Access Compliance Report

Public Rights-of-Way

(Curb Ramps)

Intersection ID: 21496	Main Street: SOUTH_BV	Cross Street: STARMOUNT_COVE_LN	Location: SE
ADA ID: D8106B3BEF55	Ramp Type: ParaDiag	Initial Pass/Fail: Fail	Overall Compliance: No
		Severity Score: 12.5

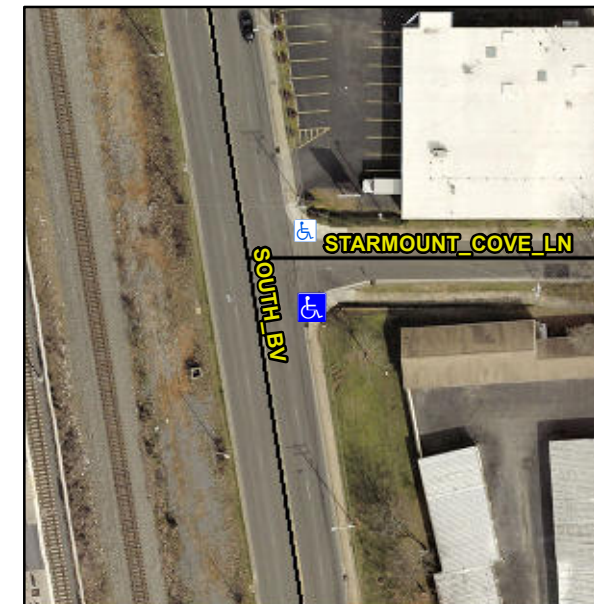
R304.3.2

Compliance	Description	Data	Compliance	Description	Data
N/A	Ramp Length LT (in)	63.0	N/A	Ramp Length RT (in)	60.0
Yes	Ramp Width LT (in)	61.0	Yes	Ramp Width RT (in)	65.0
No	Ramp Slope LT (%)	9.7	Yes	Ramp Slope RT (%)	5.1
Yes	Ramp XSlope LT (%)	1.2	Yes	Ramp XSlope RT (%)	1.7
N/A	Landing Length (in)	N/A	N/A	DWS Provided?	N/A
N/A	Landing Width (in)	N/A	N/A	DWS Contrast?	N/A
N/A	Landing Slope (%)	N/A	N/A	DWS Length (in)	N/A
N/A	Landing X Slope (%)	N/A	N/A	DWS Full Width?	N/A
N/A	Landing Curb? (Y/N)	N/A	N/A	DWS Offset (in)	N/A
N/A	Shared Landing?	N/A			
N/A	Gutter Ponding?	N/A	N/A	Gutter Slope (%)	N/A
N/A	Gutter Lip Ht (in)	N/A	N/A	Gutter X Slope (%)	N/A
N/A	Painted X Walk1?	No	N/A	Painted X Walk2?	No
	X Walk 1 Direction	To NW		X Walk 2 Direction	To W
N/A	X Walk 1 Width (in)	N/A	N/A	X Walk 2 Width (in)	N/A
	X Walk 1 Slope (%)	0.5		X Walk 2 Slope (%)	0.2
	X Walk 1 X Slope (%)	7.1		X Walk 2 X Slope (%)	1.4
N/A	Ramp inside XWalk1?	N/A	N/A	Ramp inside XWalk2?	N/A

Remove & Replace Curb Ramp With Two New Directional Ramps or Equivalent.
